Second Revision No. 10-NFPA 75-2023 [Global Comment]

Chapter 5 Performance-Based Design Approach

Second Revision No. 25-NFPA 75-2023 [Section No. 2.2]

Figure A.11.5.4.1 Examples of Potential Airflow Patterns and Corresponding Sensor Locations.

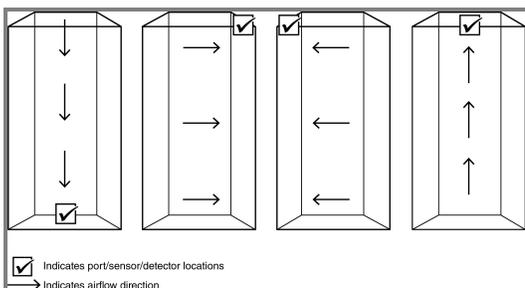
Where installed, off-gas detection systems that monitor for electrolyte vapor released prior to thermal runaway shall be listed or approved, and installed in accordance with the manufacturer's published instructions.

Committee Statement: Added requirements for electrolyte vapor gas detection, if installed. Electrolyte vapor gas detection is being installed in lithium-ion battery installations associated with UPS systems and these sections give additional guidance on how to install them appropriately.

Gas detection for the purpose of detecting flammable or explosive levels of gas should not be used as a means to detect thermal runaway. Gases produced during the off-gas event that precedes thermal runaway are flammable. However, during this early off-gas stage, limited amounts of gas are produced that would not register with flammable gas sensors that are meant to prevent explosive atmospheres. During the off-gas phase, specialized detection devices are needed that can detect trace amounts of the vaporized electrolyte that can be present at the low ppm or ppb level. Additional information on explosion protection can be found in NFPA 68 and NFPA 69 .

For off-gas detection, the detection devices should be placed near or on the battery rack to detect off-gas events from the rack. While airflow is not required for sensor operation, the airflow patterns should be taken into consideration when positioning the detection devices. Sampling ports in an aspirated gas sensing system should follow similar positioning guidance. Several examples of potential airflow patterns and their corresponding sensor placement are shown in Figure A.11.5.4.1 . In any case, manufacturer's published instructions should be followed.

Thermal runaway can also be detected using highly sensitive particulate detection. For example, an aspirated detection system that has sensing technology to allow for the detection of particles given off during the off-gas event prior to thermal runaway.

Actions to be taken once the off-gas event has been detected will depend upon a number of factors, including the design of the battery management system, lithium-ion cell chemistry, and others.
